## MARIELLA ESTATES PRO JZ24-43

### **JZ24-43 MARIELLA ESTATES PRO PLAN WITH REZONING 18.750**

Public hearing at the request of Braciolo Brothers, LLC for Planning Commission's recommendation to City Council for a Zoning Map Amendment from Residential Acreage to R-1 One-Family Residential with a Planned Rezoning Overlay. The subject site is approximately 9.4 acres and is located west of Garfield Road, on the north side of Eight Mile Road (Section 31). The applicant is proposing to develop 10 single family lots.

# PLAN REVIEW CENTER REPORT

REVISIONS:  
 SCALE: 0 25 50  
 1" = 50 FEET  
 DR. SK. CH. CR.  
 P.L. CR.  
 BOOK ---  
 JOB 23002817  
 SHEET NO. 04

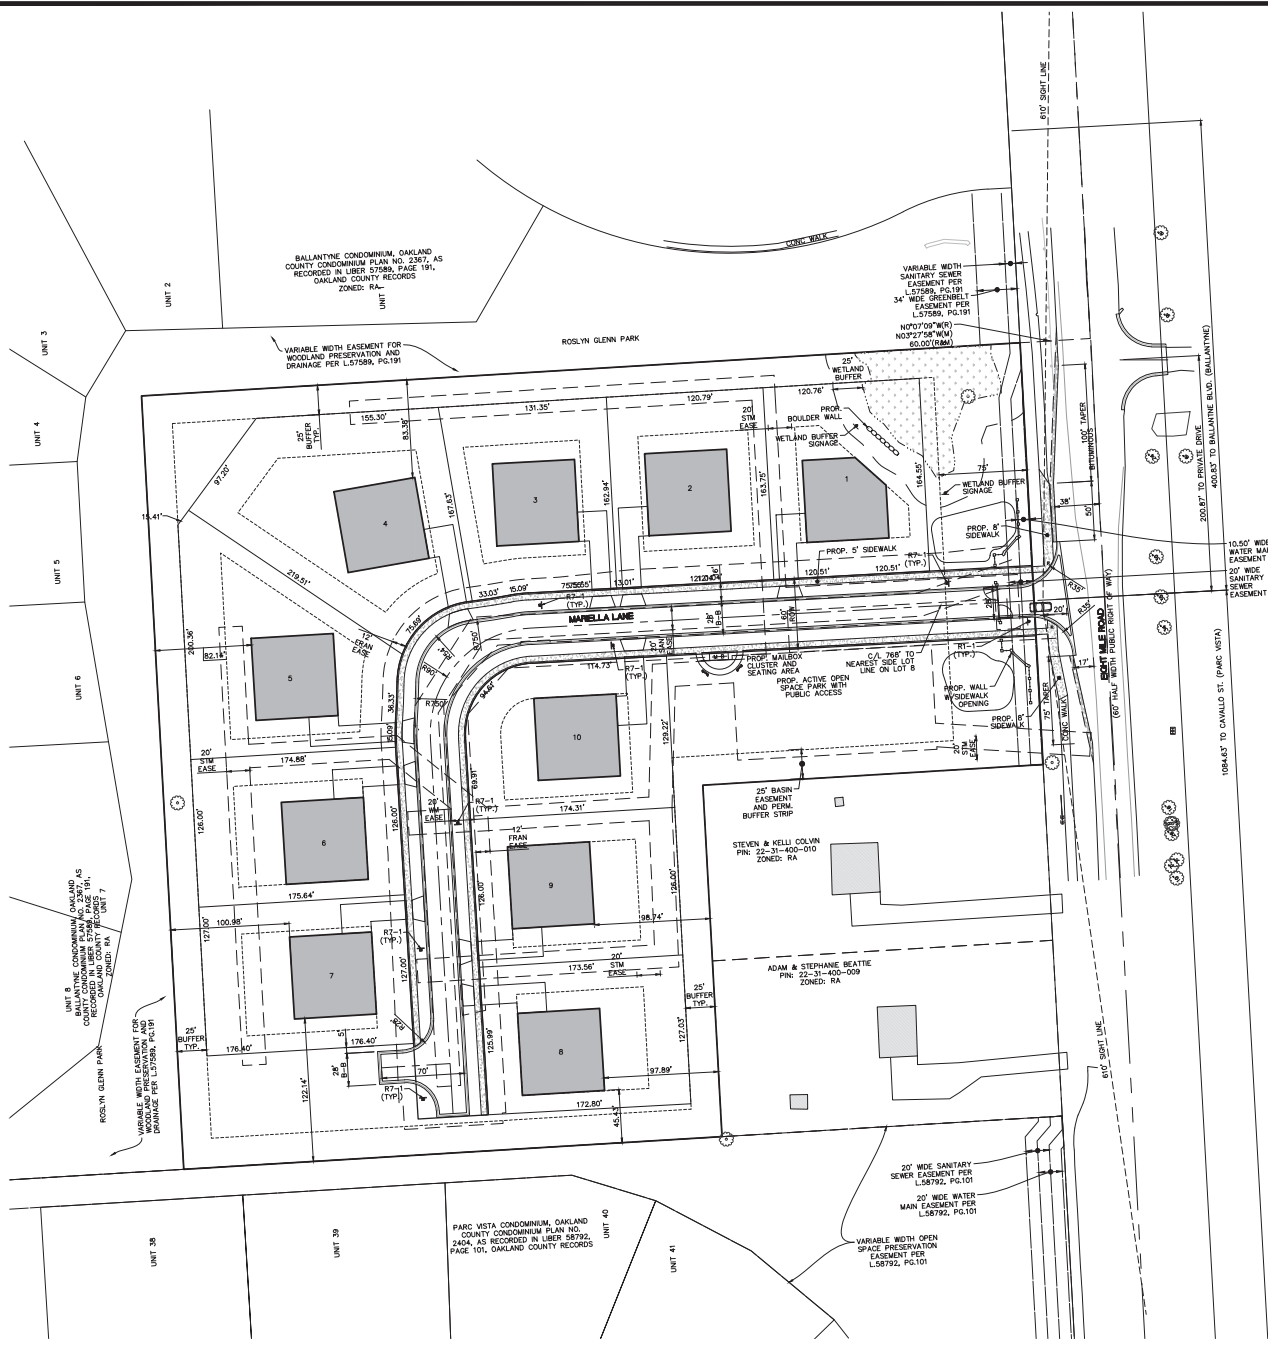
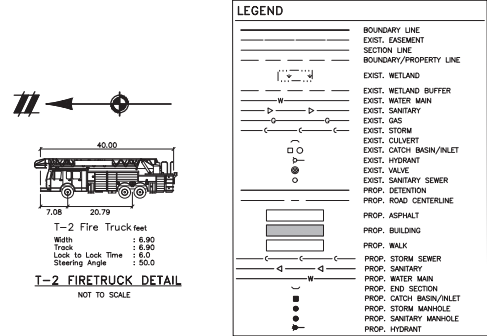
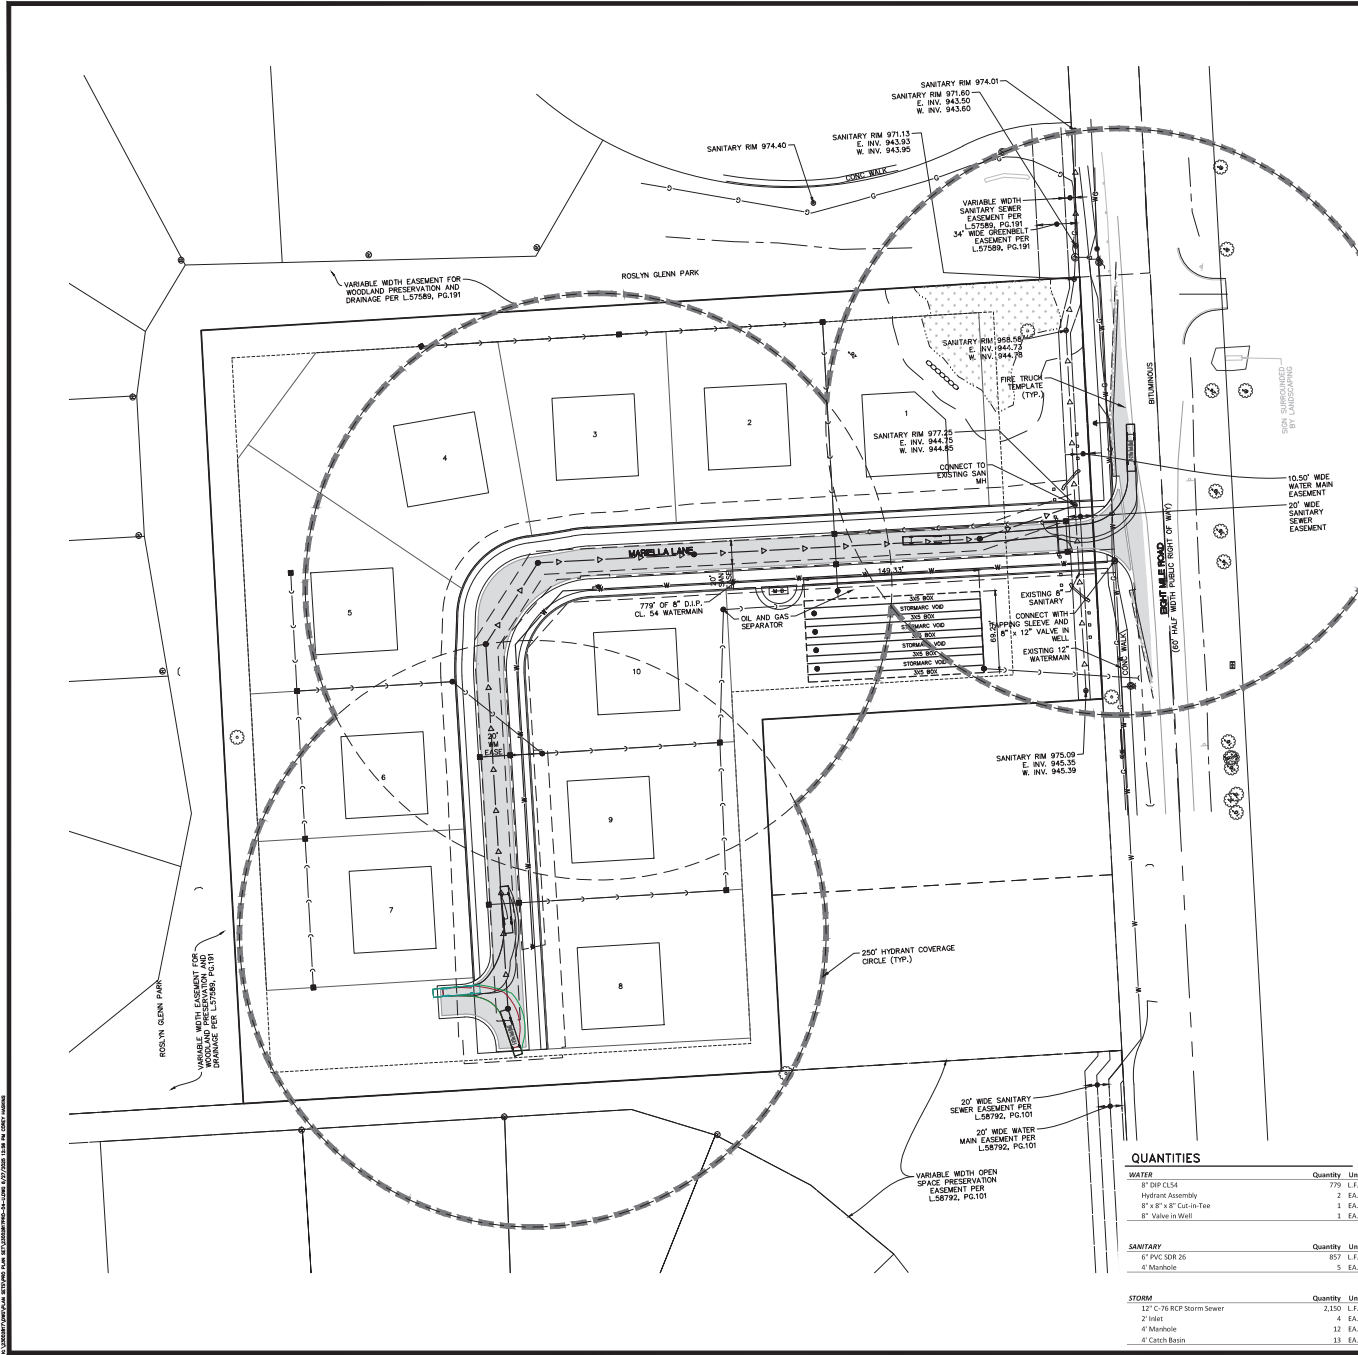
3. Sheet 04 Layout Notes state that the road will not be gated and that roads will be private, the plan shows a gate at the entrance and the road is labeled with 60' ROW. Clarify if roads will be private, revise note to state 60' private road ROW.

DR. SK. CR  
P.L. CR  
BOOK ---  
JOB 23002817  
SHEET NO. 05

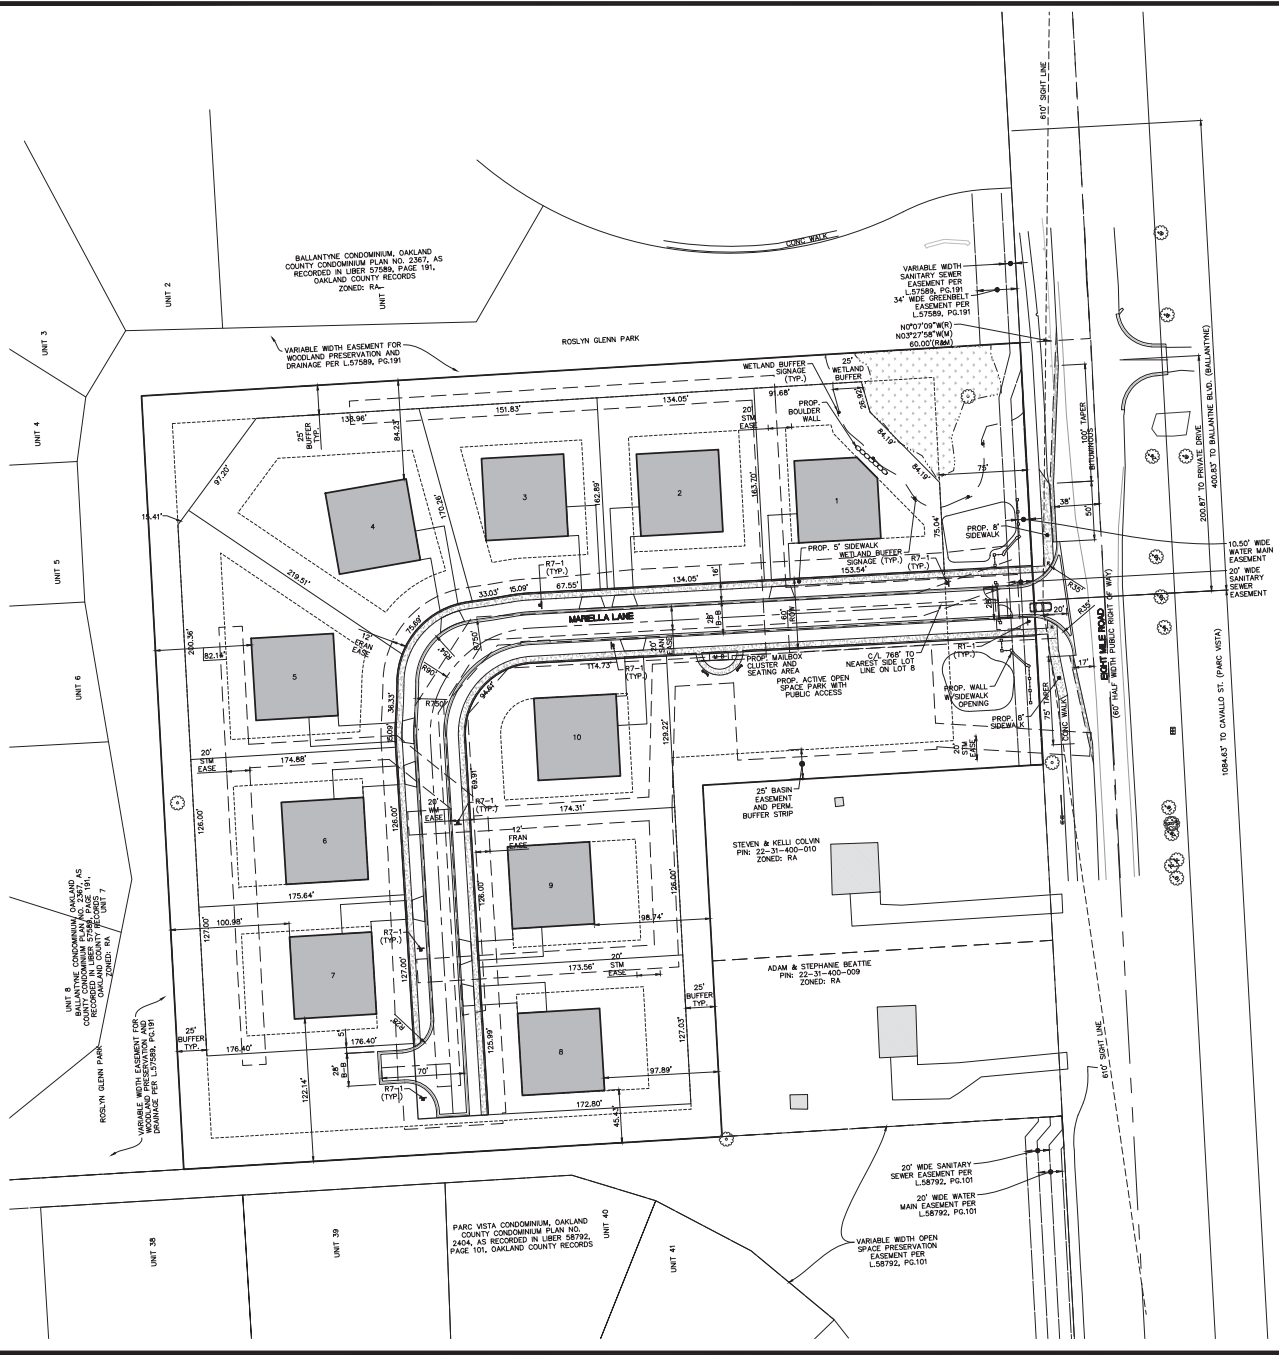
- **All fire hydrants MUST be installed and operational prior to any combustible material is brought on site. IFC 2015 3312.1. ONE additional hydrant is needed near lot #1. Sheet #5 only shows 2 hydrants being added to new water main.**

- Fire apparatus access drives to and from buildings through parking lots shall have a minimum fifty (50) feet outside turning radius and designed to support a minimum of thirty-five (35) tons. **(D.C.S. Sec 11-239(b)(5)). Sheet #5 indicates 45’ turning radii. Have this updated and include 50’ turning capabilities.**

Figure 1 – City of Novi Woodlands and Wetlands Map  
Attachment A – Site Photographs

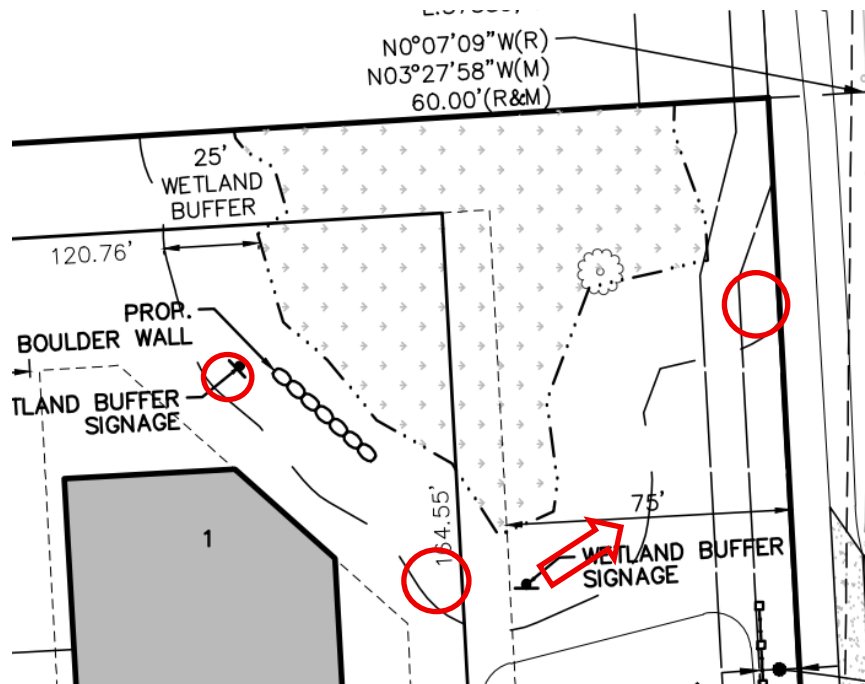
1. The applicant provided an updated *Wetland Delineation and Threatened and Endangered Species Assessment* dated June 26, 2025. The applicant identified one mixed emergent and forested wetland in the southeast portion of the site. The area is also characterized by a flooded/open water portion. Merjent conducted a site visit on July 1, 2025 and found flagging on-site consistent with the site plan. Photos from the site visit are included as **Attachment A**.
